Date..... August 6, 2007

West Lakes Properties LC - 300 County Line Road

ZON2006-00193

Conceptual Plan Southern Ridge a Planned Unit Development in the City of Des Moines, County of Warren, State of Iowa

PUD-02 02 / 04

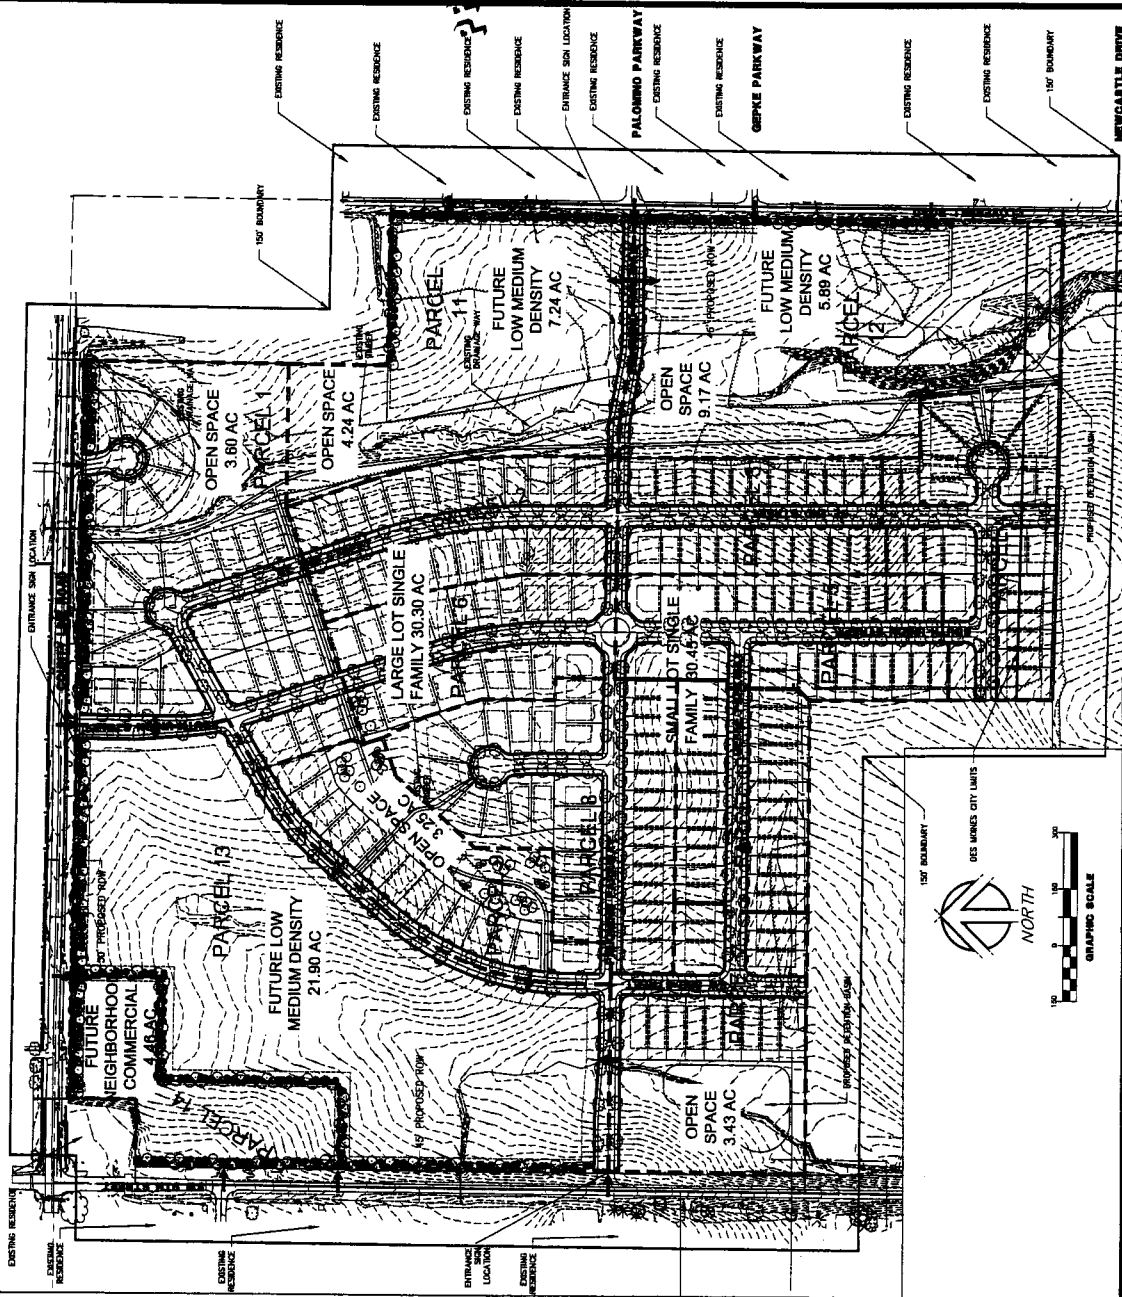
- 2) Addition of a note on Sheet 2 indicating that the Future Low/Medium Density Residential and Future Commercial areas are subject to future amendments to the PUD Concept Plan.
